# UNITED STATES PATENT AND TRADEMARK OFFICE

10/500,583

<b>Office Action Summary</b>	<b>Application No.</b> 10/500,583	<b>Applicant(s)</b> WEBJORN, JAN	
	<b>Examiner</b> NAHID AMIRI	<b>Art Unit</b> 3679

## **DETAILED ACTION**

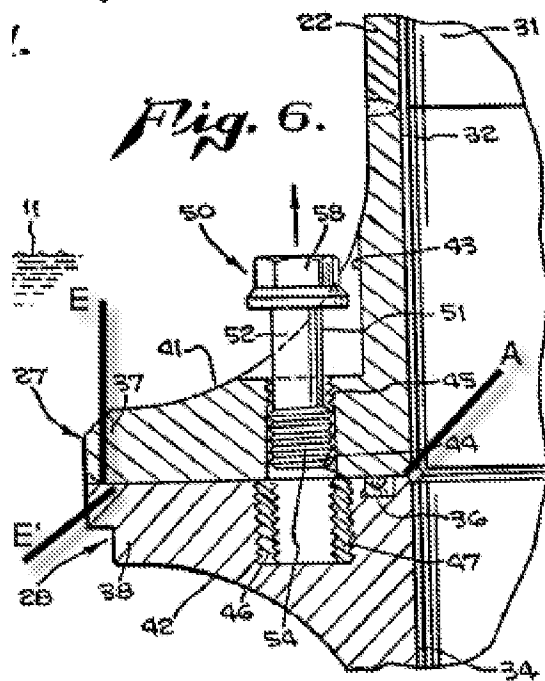
With respect to claim 1, it should be noted that the claim drawn only to one flanged member. Accordingly, as claimed, Watkins et al. disclose a flanged member (Fig. 6) configured to be included as a first flanged member (37) in a flanged joint in a pressure equipment device, the flanged joint comprising the first flanged member (27) and a corresponding second flanged member (38) with a second flanged end having a second end surface (E'), said first flanged member (37) comprising a first flanged end with a first end surface (E) which capable of corresponding to the second end surface (E') of the second flanged end of the second flanged member (38), at least a portion of the first load transferring surface in an unstressed condition being concave (constituted by a curved portion of an innermost portion of the first flange 37) in radial direction, such that the at least the portion of the first load transferring surface is curved and defined by a concave curve function, the first end surface (E) comprising a first load transferring surface through which forces are transferred when assembled together with the corresponding second flanged member; in a radial direction; wherein load transferring surface has an outermost abutment point (A) in a cross section of the first flanged member (37), the outermost abutment point (A) configured to abut against the second end surface of the second flanged member (38) when assembled together with said corresponding second flange member (38), the outermost (A) abutment point being the abutment point situated farthest in the radial direction from the central axis of the first flanged member (37), said load transferring surface has an innermost abutment point in a cross section of the first flanged member, the innermost abutment point configured to abut against the second end surface of the second flanged member when assembled together with said corresponding second flange member, the innermost abutment point being the abutment point situated nearest in the radial direction from the central axis of the first flanged member (37); and a boring (44) passing through the first end surface (E) at a radial distance from a central axis of the first flanged member (37) greater than the radial distance from the central axis of the first flanged member (37) to the innermost abutment point, and less than the radial distance from the central axis of the first flanged member to the outermost abutment point.

With respect to claim 11, Watkins et al. disclose a joint (Fig. 6) comprising a first flanged member (37) and a second flanged member (38) adapted for a pressure equipment device, said two first and second flanged members (37, 38) each comprising at least one flanged end having an end surface ( E, E') comprising a load transferring surface through which forces are transferred when connecting together said two first and second flanged members (37, 38) in an assembled state, such that in the assembled state said each load transferring surface faces the other load transferring surface, wherein, for the first flanged member (37), at least a portion of the end load transferring surface in an unstressed condition is concave in a radial direction, such that the at least the portion of the end load transferring surface is defined by a concave curve function, said load transferring surface is concave in the radial direction over at least an area that is subjected to deformation when the first flanged member is assembled together with said second flanged member, and a proximal point on the at least the portion of said load transferring surface and a distal point of the at least the portion of said load transferring surface meeting a plane inclined in the radial direction of said flanged member wherein said load transferring

surface has an outermost abutment (A) point in a cross section of the first flanged member (37), the outermost abutment point configured to abut against the end surface of the second flanged member (E') when assembled together with said corresponding second flange member (38), the outermost abutment point being the abutment point situated farthest in the radial direction from the central axis of the first flanged member (37), said load transferring surface has an innermost abutment point (B) in a cross section of the first flanged member (37), the innermost abutment point (B) configured to abut against the end surface of the second flanged member (38) when assembled together with said corresponding second flange member (38), the innermost abutment point (B) being the abutment point situated nearest in the radial direction from the central axis of the first flanged member (37); and a boring (44) passing through the end surface of the first flanged member (37) at a radial distance from a central axis of the first flanged member (37) greater than the radial distance from the central axis of the first flanged member (37) to the innermost abutment point (A), and less than the radial distance from the central axis of the first flanged member to the outermost abutment point.

With respect to claim 12, Watkins et al disclose (Fig. 6A) that the first and second flanged members (37, 38) each have a concave end load transferring surface (defined by an end innermost portion point of the first and second flanges 37, 38).

With respect to claim 16, Watkins et al disclose (Fig. 6A) that the load transferring surfaces of each of the first and second flanged members (37, 38) is configured to directly contact the load transferring surface of the remaining flanged member.

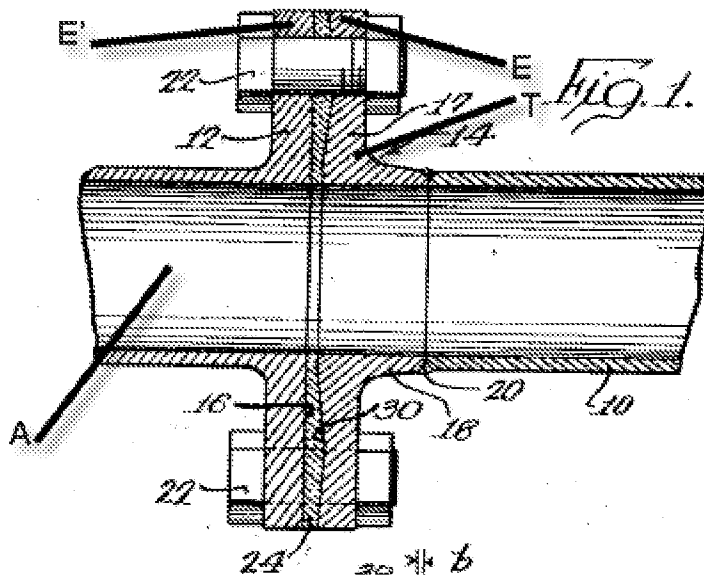
With respect to claims 1 and 2, it should be noted that the claim drawn only to one flanged member. Accordingly, as claimed, Buono discloses a flanged member (Fig. 1) configured to be included as a first flanged member (14) in a flanged joint in a pressure equipment device, the flanged joint comprising the first flanged member (14) and a corresponding second flanged member (12) with a second flanged end having a second end surface, said first flanged member (14) comprising a first flanged end with a first end surface (E) which capable of corresponding to the second end surface of the second flanged end of the second flanged member (12), the first end surface (E) comprising a first load transferring surface through which forces are transferred when assembled together with the corresponding second flanged member; in a radial direction; wherein load transferring surface has an outermost abutment point in a cross section of the first flanged member (14), the outermost abutment point configured to abut against the second end surface of the second flanged member (14) via the gasket (16) when assembled together with said corresponding second flange member (14), the outermost abutment point being the abutment point situated farthest in the radial direction from the central axis of the first flanged member, said load transferring surface has an innermost abutment point in a cross section of the first flanged member, the innermost abutment point configured to abut against the second end surface of the second flanged member when assembled together with said corresponding second flange member, the innermost abutment point being the abutment point situated nearest in the radial direction from the central axis of the first flanged member; and a boring passing through the first end surface at a radial distance from a central

axis of the first flanged member greater than the radial distance from the central axis of the first flanged member to the innermost abutment point, and less than the radial distance from the central axis of the first flanged member to the outermost abutment point. Buono fails to disclose that at least a portion of the first load transferring surface in an unstressed condition being concave such that the concave of the first end surface is curved; and wherein the first load transferring surface is concave over the entire extension thereof in the radial direction. It would have been obvious to one of ordinary skill in the art at the time of invention was made to form the concave of the first end surface as a curve instead of forming it from multi-straight lines, since there is no known criticality associated with the concave being curved and it is well-established that changes in shape are obvious expedients. The change in shape of the concave produces no new and unexpected results.

With respect to claim 5, Buono discloses (Figs. 1-3) wherein the first load transferring surface (30) comprises a varyingly concave surface in the radial direction; and wherein the part surface has different radii of curvature.

With respect to claim 10, Buono discloses (Fig. 1) that at least a part of a transition area (T) (see attachment), between the surface of the flange directed away from the end surface (30)

and a part of the first flanged member that is substantially parallel to a longitudinal axis of the member, is shaped as a substantially elliptical area.

With respect to claim 14, 15, 17, and 18, Buono discloses (Fig. 1) that the concave surface has more than one radii of curvature; wherein the first load transferring surface is configured to contact directly the second end surface; and wherein at least the portion of the first load transferring surface in the unstressed condition that is concave comprises a majority of the first load transferring surface; and wherein the second flanged member (12) is identical with the first flanged member.(14).
